## North Westerly - PD zoning 4th Review

To: John Prestwich, PCS Group  
From: Aly Burkhalter, Senior Planner  
Date: March 13, 2025  
Re: PD-001700-2024 North Westerly - PD

#### 4<sup>th</sup> Review & Referral Comments

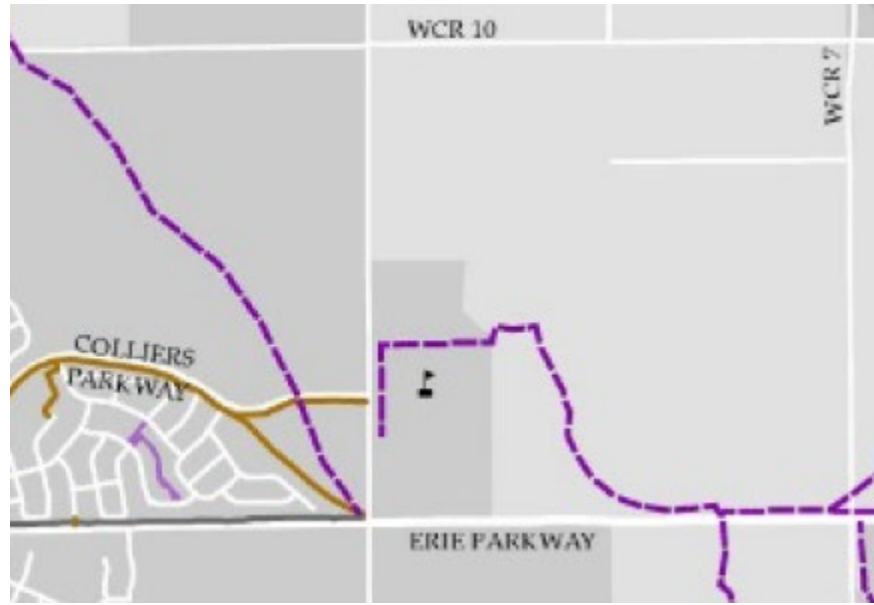
- 1) Show trails on this map in order to understand how the trail system and the street network correlate. It is the intent for the Town to take over maintenance of the multi-use trail system as part of its spine trail system and should be shown differently than internal local connectors.

Response: We have included a trails map.

1  
OF 22

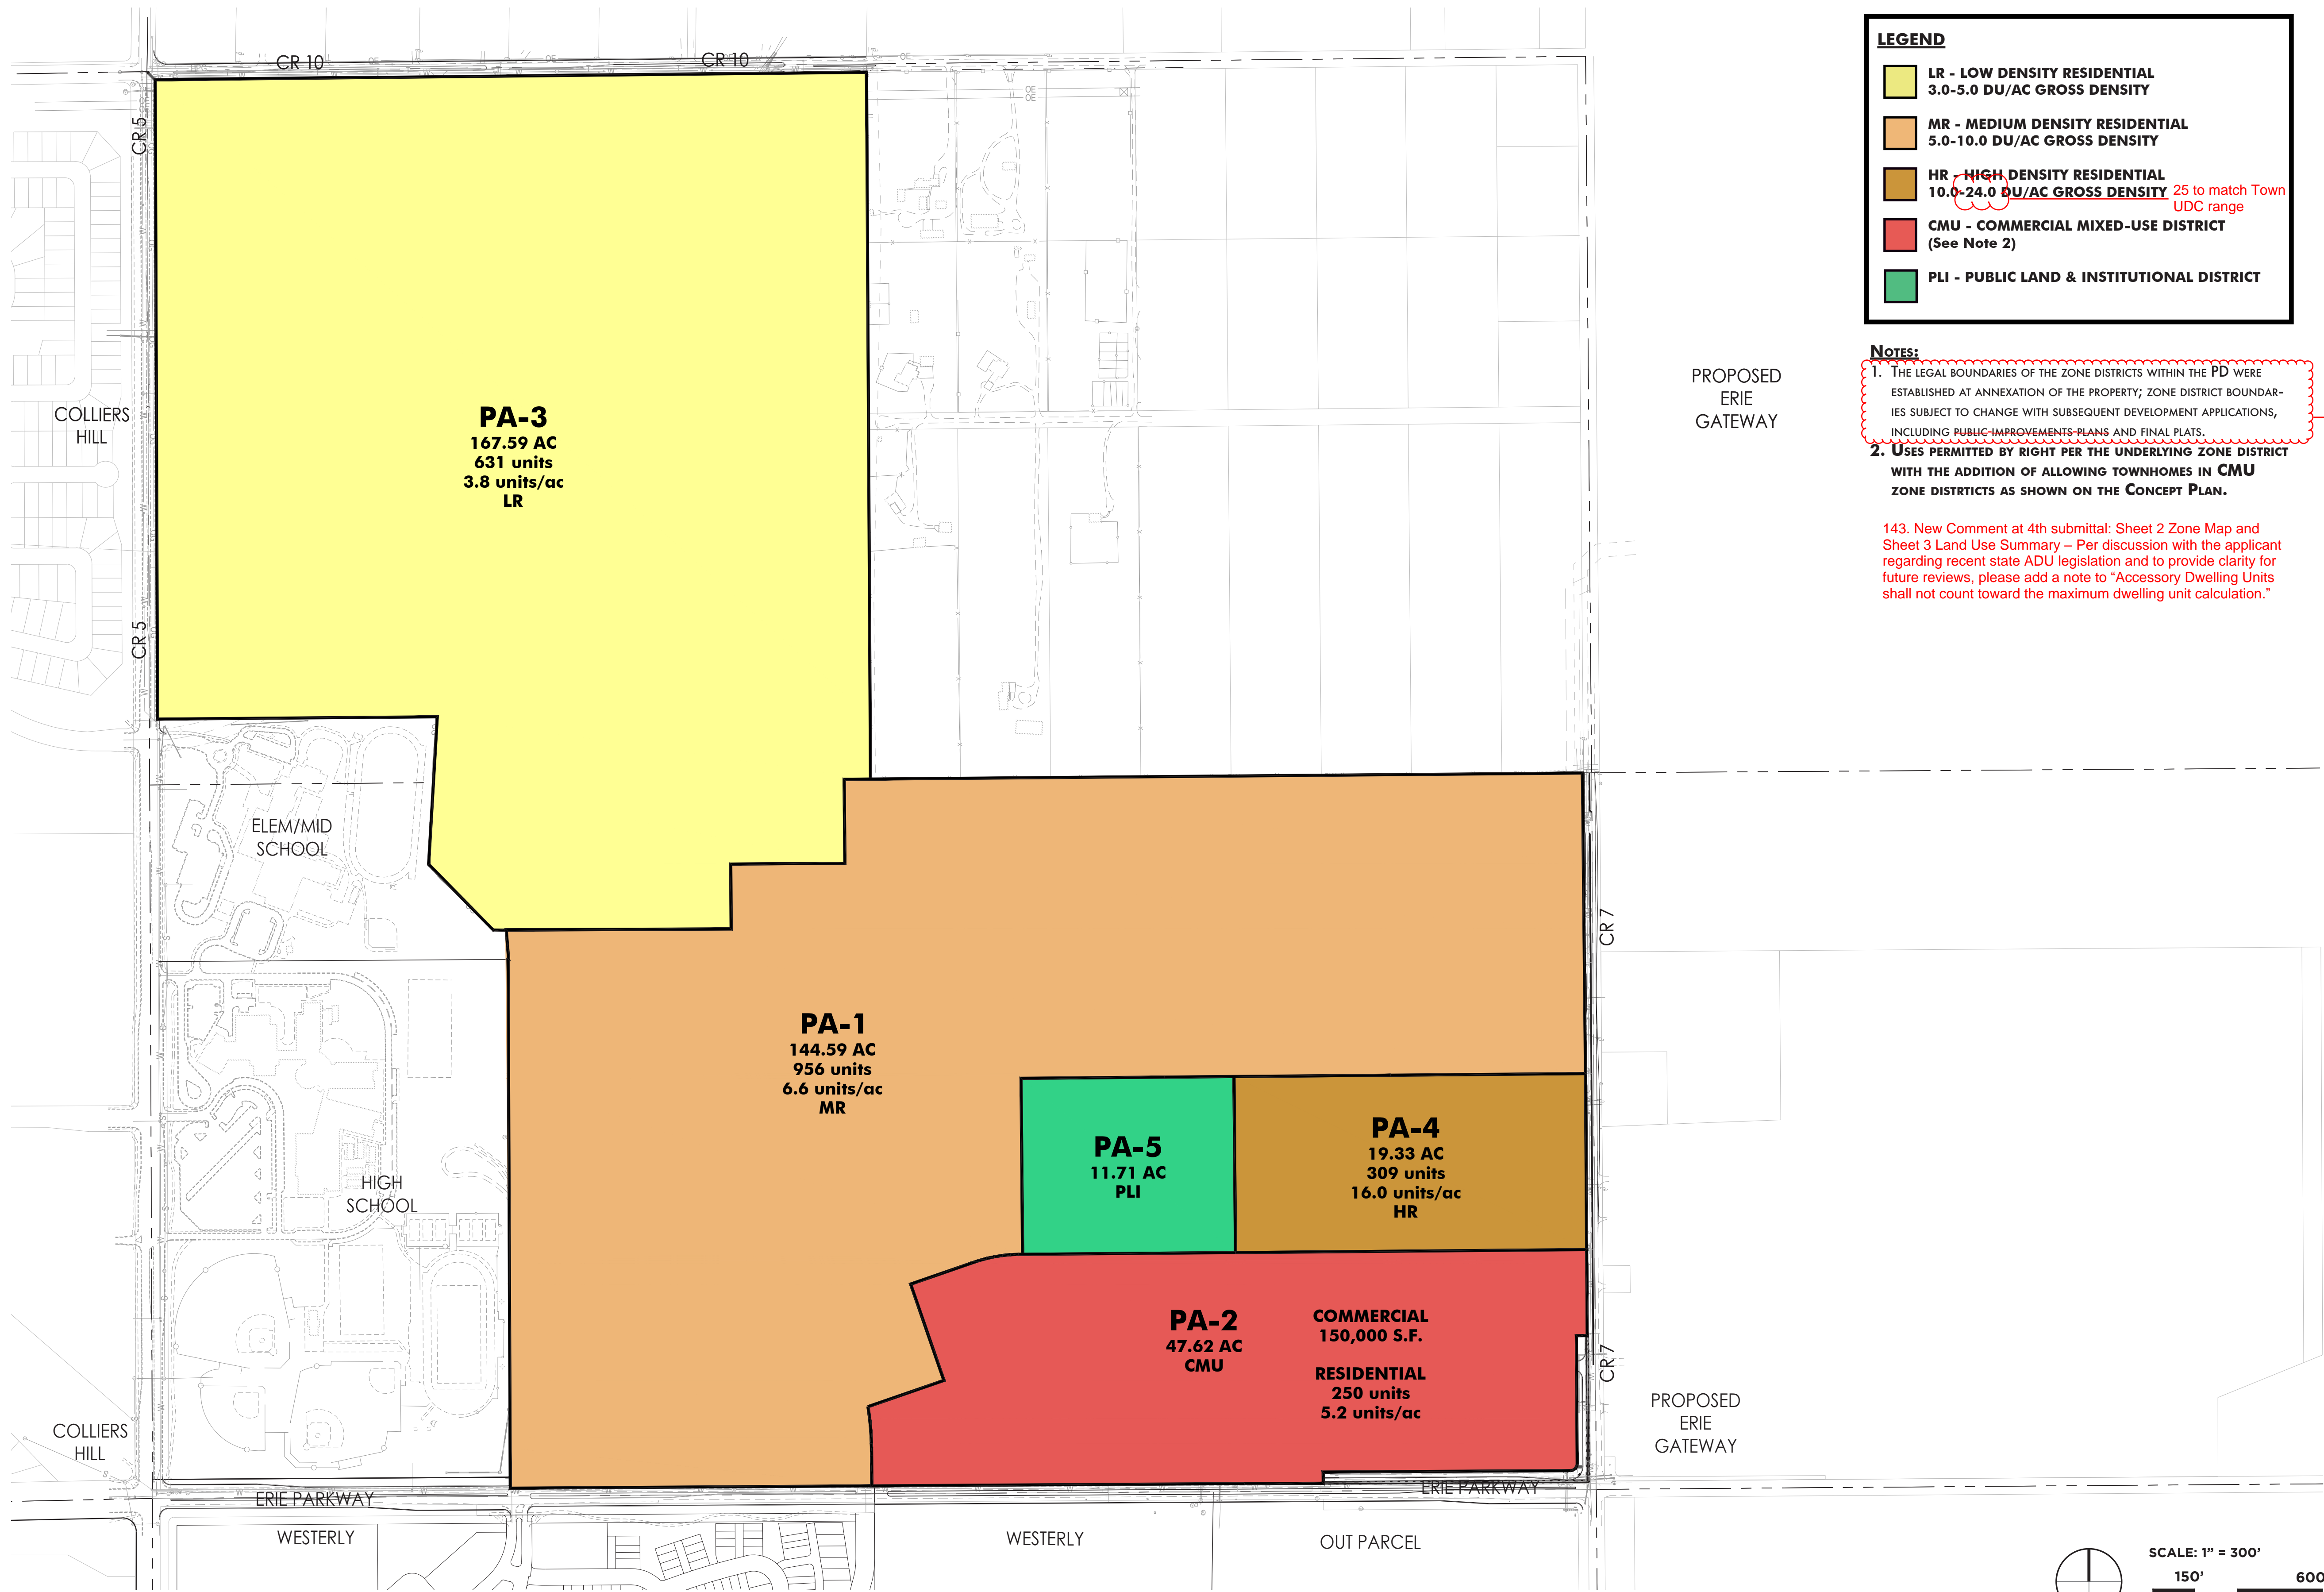
141. New Comment at 4<sup>th</sup> submittal: Sheet 1 of PD Development Guide – The vested rights language should be as follows: "This PD constitutes a site specific development plan as defined in C.R.S. § 24-68-101, *et seq.*, and Chapter 3 of Title 9 of the Erie Municipal Code and shall create vested property rights for 7 years from the date of approval of the PD-DP, provided that all required procedures are followed. If building permits for at least 50% of the units contemplated by this PD have been issued within 7 years of the date of the Town's final approval of this PD, the vesting term shall be automatically extended for an additional 3 years."

## UNDERMINING PLAN

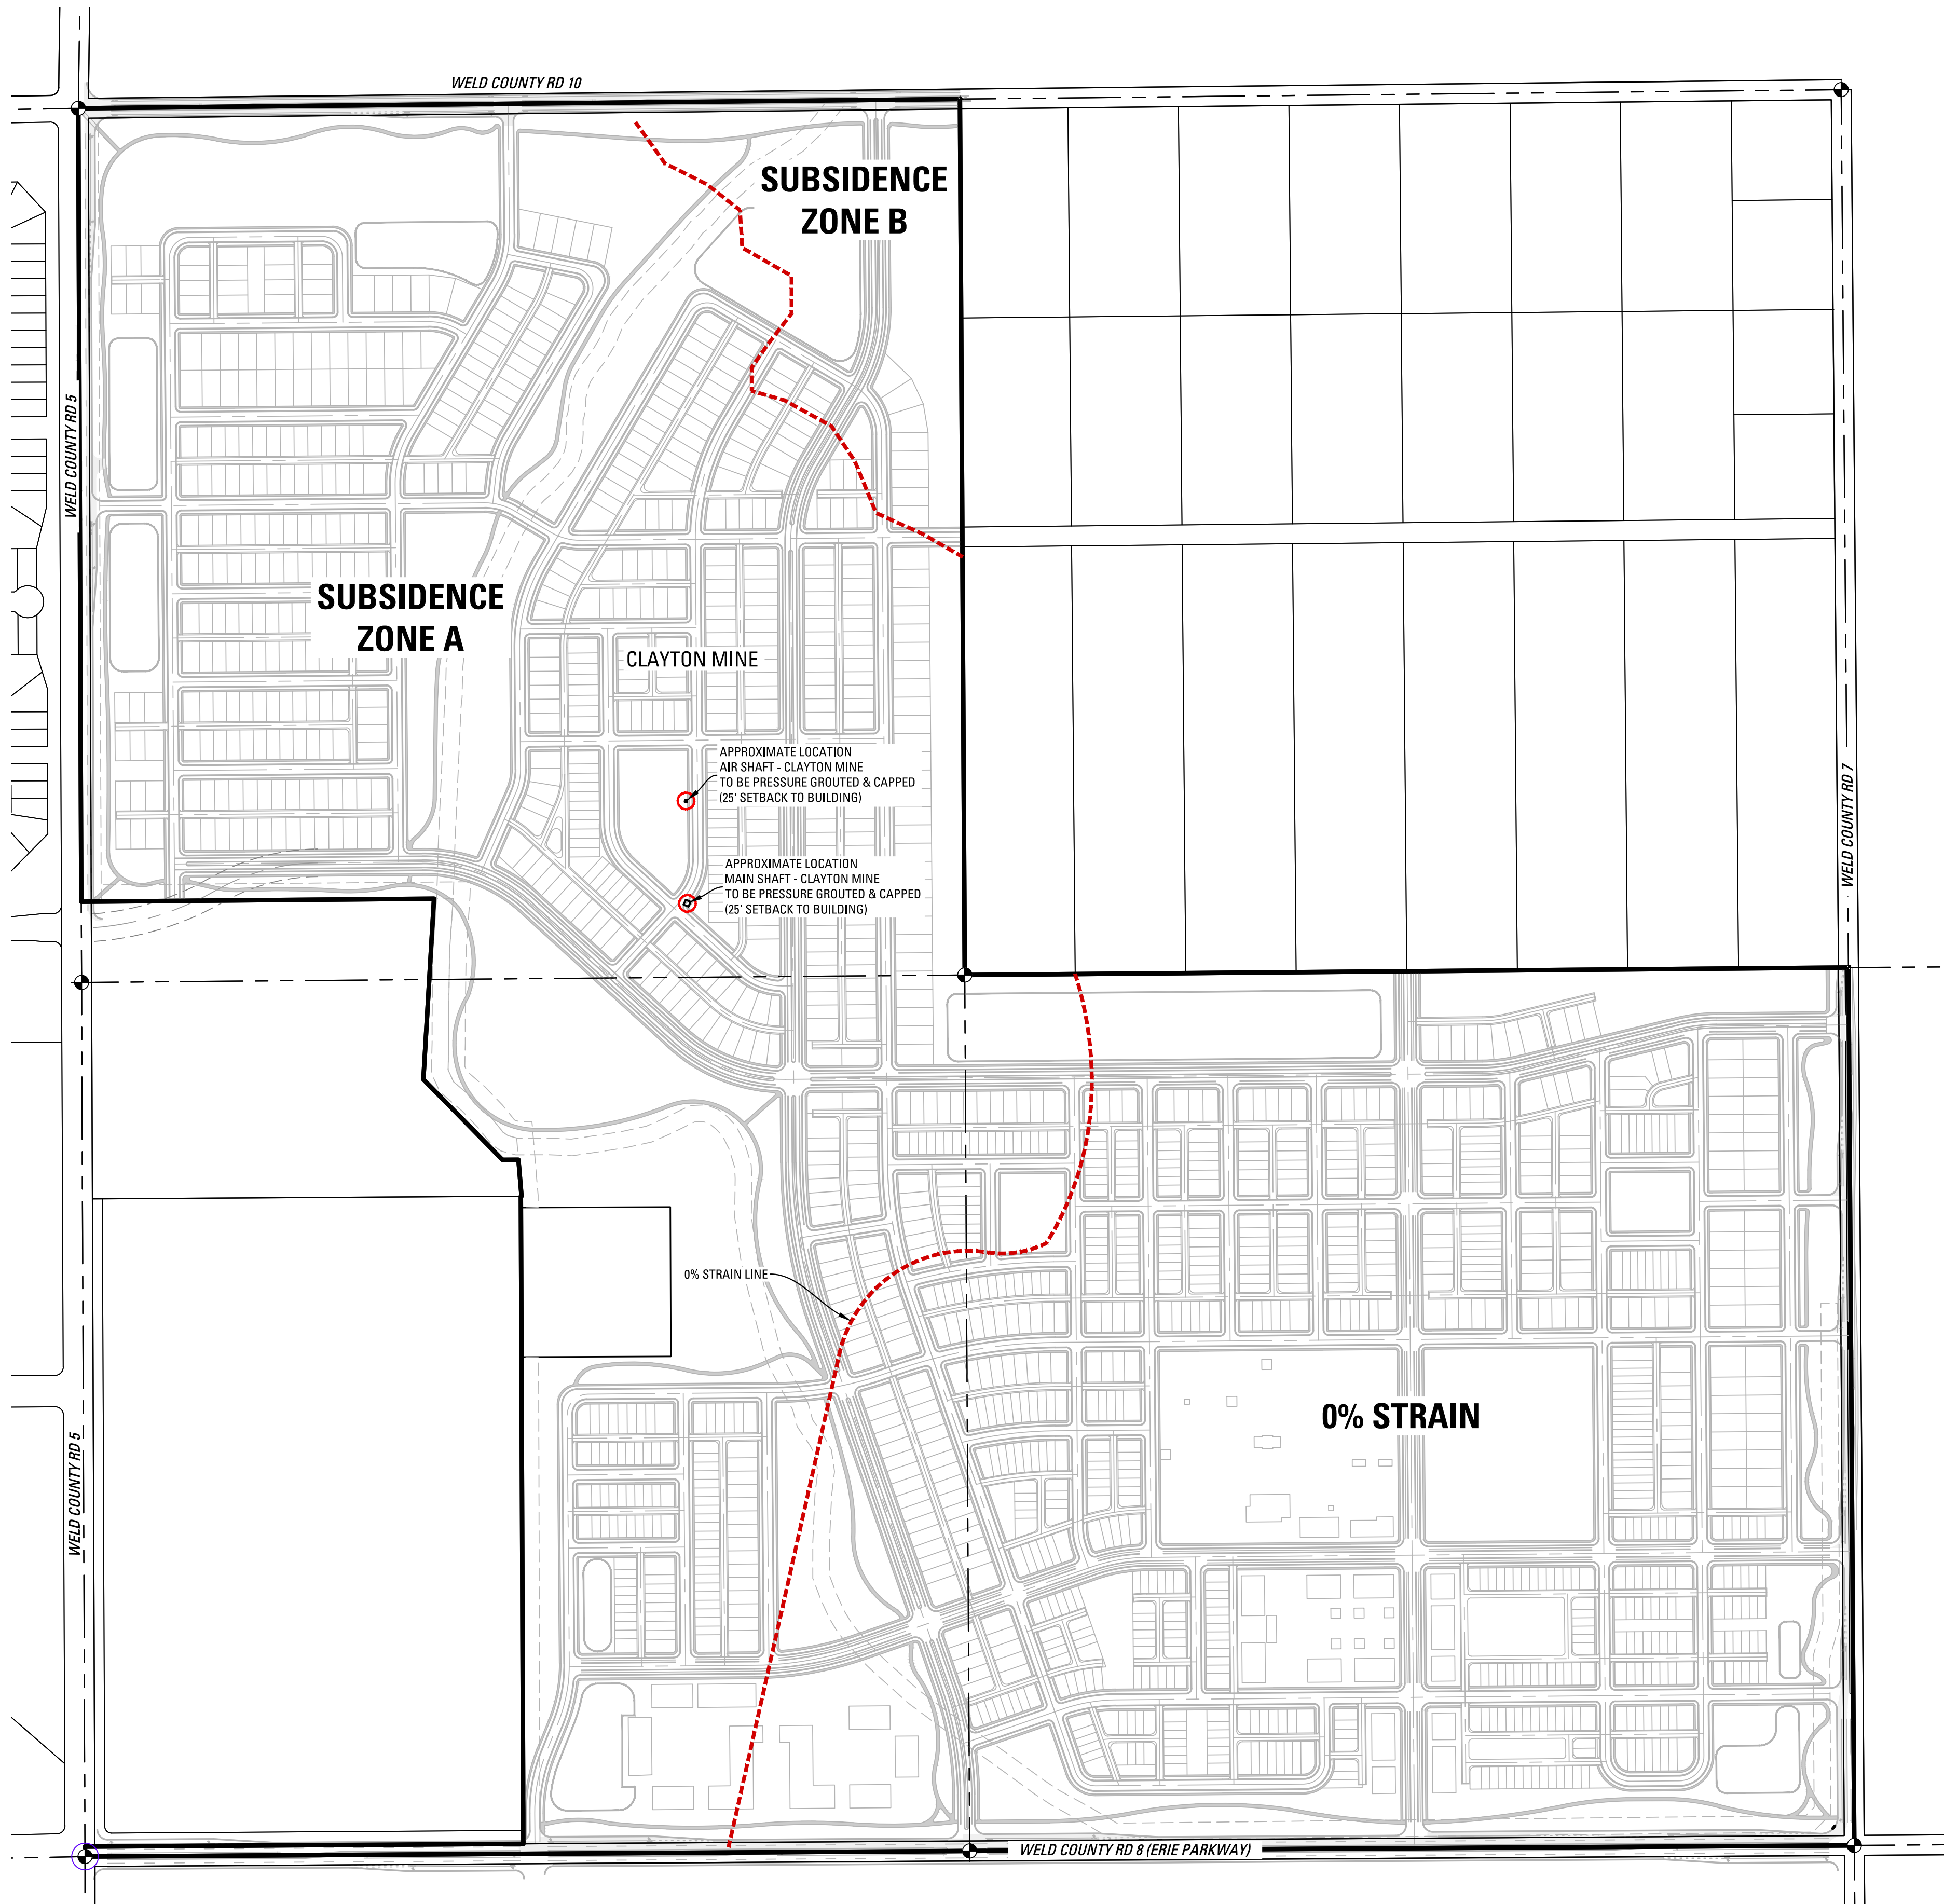
**# 9f Undermining Plan (Sheet 13)** – see CGS comments. Please follow the direction provided by Colorado Geologic Survey regarding geotechnical considerations and mine subsidence as these present potentially significant impacts which could alter development

111. It is indicated in the Mine Subsidence Report that buildings should be limited to less than 165-ft and two-stories or less in the Subsidence Zone A. It is unclear where this area is indicated on Undermining Plan (Sheet 13 of the PD Zone Map and Guide).

Sheet 13, Undermining Plan, of the North Westerly PD Zoning Map and Guide (2/14/2025) is consistent with Western Environment's 7/11/2024 recommendations. CGS therefore has no objection to North Westerly PD (PD-001700-2024) approval, but please keep CGS in the loop at preliminary plat so we can check shaft locations and setbacks. **All shafts must be field located, surveyed, stabilized & capped, and the correct locations and setbacks shown on the plat.**
